**Subject: Beaver Valley Power Station, Unit Nos. 1 and 2
BV-1 Docket No. 50-334, License No. DPR-66
BV-2 Docket No. 50-412, License No. NPF-73
Response to a Request for Additional Information (RAI dated August 2,
2005) in Support of License Amendment Request Nos. 302 and 173,
Extended Power Uprate**

REQUEST FOR ADDITIONAL INFORMATION RELATED TO

BEAVER VALLEY POWER STATION, UNIT NOS. 1 AND 2 (BVPS-1 AND 2)

EXTENDED POWER UPRATE (EPU)

Figure 1-1

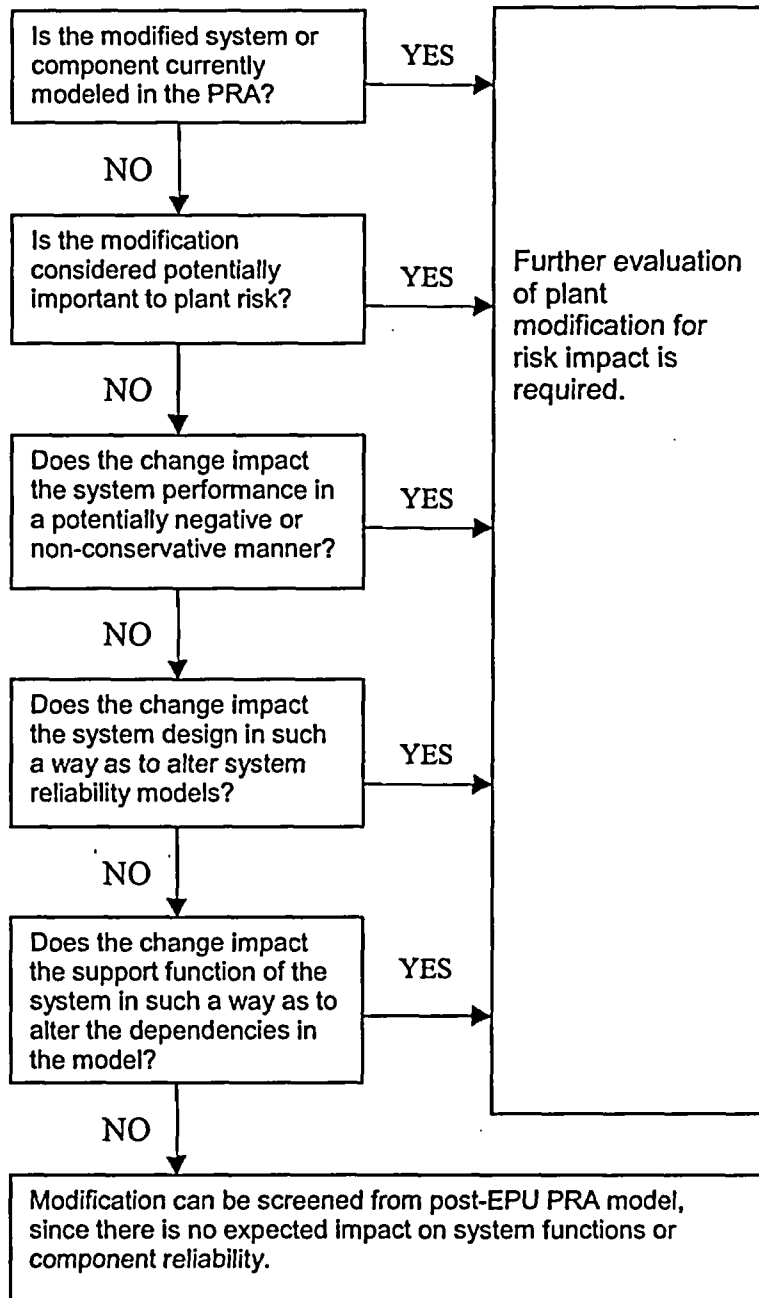
- b. For EPU-related change packages, please provide the details of these reviews for BVPS-1 and 2, including the effect of each modification on the probability risk assessment (PRA) model.

An evaluation was performed as a two-step screening process. The end result determined whether there is a significant impact on risk due to a plant modification. The two steps are outlined below and shown on Figure 1-1. In each step, if the criterion can be answered in the negative for a given component, that component can be eliminated from further consideration, as it is considered to have no impact or a negligible impact on risk.

Step 1: Is the modified system or component currently modeled in the PRA, or not modeled and considered potentially important to plant risk? – Modifications to components that are currently included in the PRA model will be evaluated for risk impact.

In the event a component is not included in the PRA model, yet the component is determined to be potentially important to plant risk, and therefore should be included in the PRA model, the component will be evaluated for risk impact. Potential risk impact for components not included in the PRA model are determined by engineering judgment.

Step 2: Modification meets guidelines in Standard Review Plan 19.0:

- Does the change impact the system performance in a potentially negative or non-conservative manner?
- Does the change impact the system design in such a way as to alter system reliability models?
- Does the change impact the support function of the system in such a way as to alter the dependencies in the model?

If the answer to all of these criteria is no, then there is no expected impact on system function or component reliability due to the plant modification.
